Changes in ARQ

IEEE C802.16d-03/52

Meeting #26 of IEEE 802.16 WG

This document is to be presented to 802.16 TGd to fix 802.16d document

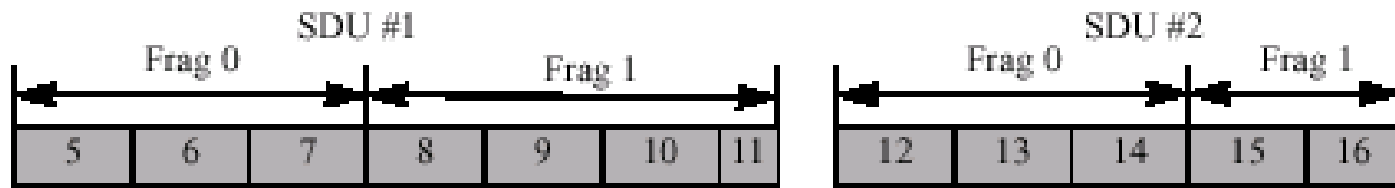
- So the fragment size should be less than that
- It means that having middle size packet e.g. 480 bytes we have to split it into 10 fragments (and probably pack into a single MAC PDU).
Otherwise SS may have no choice but to discard all fragments waiting for retransmission each time when BS provides narrow channel. There is no mechanism to inform SS why it was decided
- **We have to keep fragment size low even if at the moment everything is OK (lot of bandwidth)**

Figure 139—Block usage examples for ARQ transmissions and retransmissions

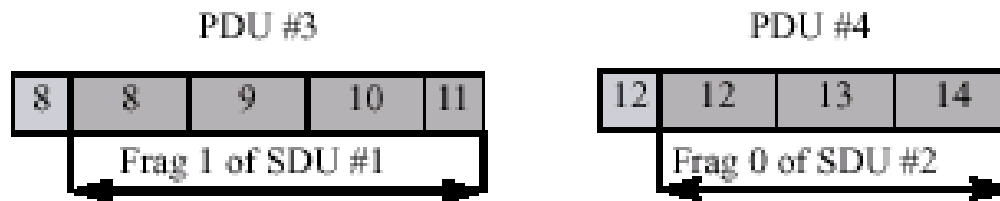
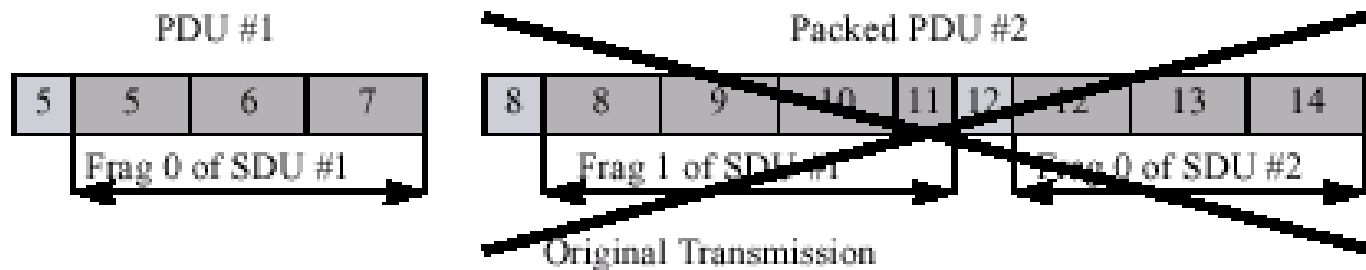
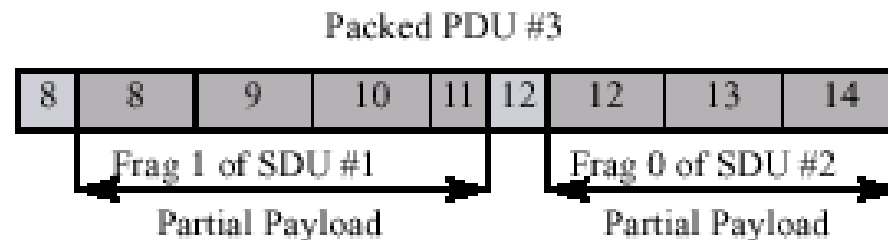
- Return to block-based ARQ (802.16-D1) where block size [not fragment size] is small enough to fit into MAC frame at the lowest possible data rate
 - Allows re-fragmentation so we **don't need anymore fragment packets while everything is OK**
- We may keep unchanged fragmentation/packing at connections with ARQ disabled

Two consecutive SDUs presented to MAC for the same connection,

Retransmission of PDU without rearrangement

- Copy from 802.16a-D1 to replace the correspondent items in 802.16a-D5
 - Figure 135—SDU encapsulation and ARQ Block Numbering in PDUs Table 164—Format of 2 - 11 GHz Fragmentation sub-header
 - Table 165—Format of 2 - 11 GHz Packing sub-header
 - Section 6.2.4.1 Block Numbering Scheme
 - Replace throughout the text Fragment Sequential Number (FSN) to Block Sequential Number (BSN)
 - ...
